# Town of Glastonbury

**GL-2012-03**

**Fiber Backbone Cabling**

**Addendum #2**

Exhibit A

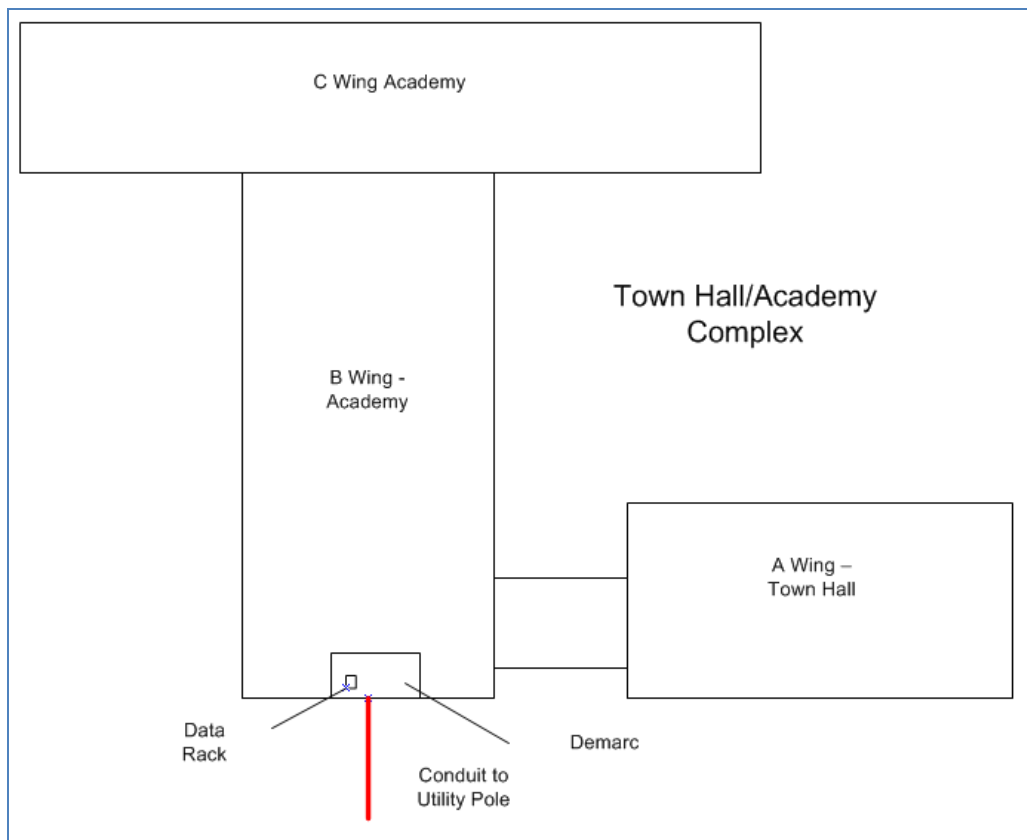
Question 6: Is there a building layout for TownHall/Academy?

**Fiber Termination Location:** The cable will enter via underground conduit and terminate in a new rack mount enclosure in the Demarc Room. The other end routes all the way back to Glastonbury High School and routes into the Splice Cabinet. The conduit to the street is less than 200' and the demarc room is about 12'X18'.

**Fiber Cable Route:** The cable routes from the Glastonbury High School Network Operations Center to the Academy Demarc room.

Answer: A layout has been generated and is added to the bottom of this addendum as Exhibit A.
